学術論文誌（Journal Paper）に修士論文の研究が掲載されるまで

自称「逆ブラック研究室」の一端のご紹介

Flexible Core Design of Super FBR with Multi-Axial Fuel Shuffling

Figure1. The concept of TPFA

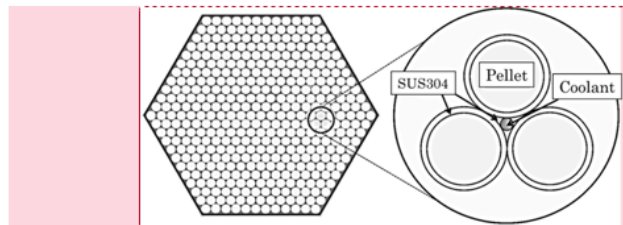
Introduction にこの図は不要でしょう。

Figure2. Flow chart of coupled core calculation (Someya and Yamaji, 2016)

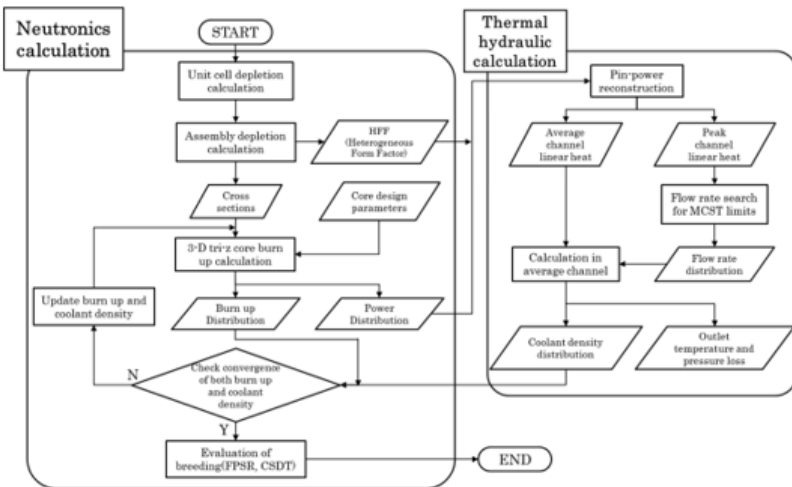
この図はたとえ引用するにしても、著作権の問題があって全く同じ図をそのまま使うことはできません。

Figure 4. ~~A~~The axial power distribution in each with different batch and shuffling at

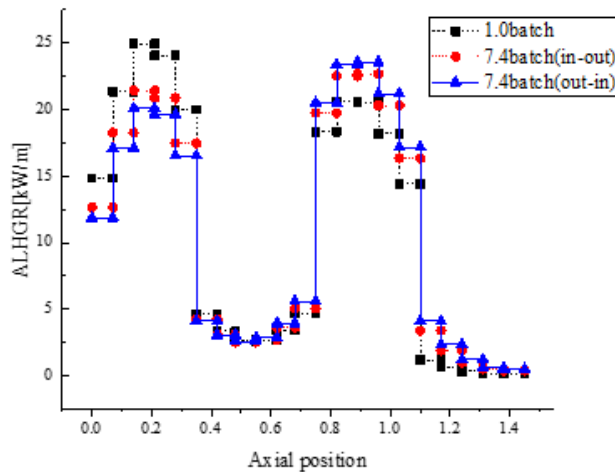
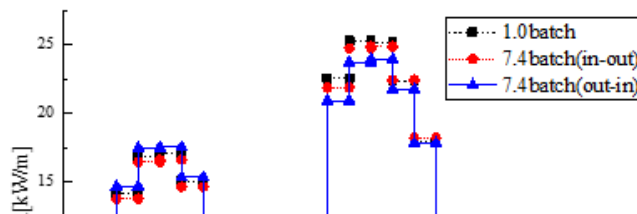
グラフの枠は右端と上にも。メモリは Y 軸のように枠の内側に向かって (X 軸は外側に向かって) いるので修正)。グラフ中の文字フォントサイズはもう少し大きい方がよい。Origin の図はそのまま貼り付けると、Origin がインストールされていない PC で正しく表示されるかどうか分からないので JPG 等の画像ファイルにして張り付けた方が安全。これらのコメントはこれ以降のほとんど全ての図にも共通です。

X 軸は単位は？ X 軸の範囲が不適切。下限はゼロ。上限も 1.4 までしかメモリが無いのは不適切。Y 軸も同様。
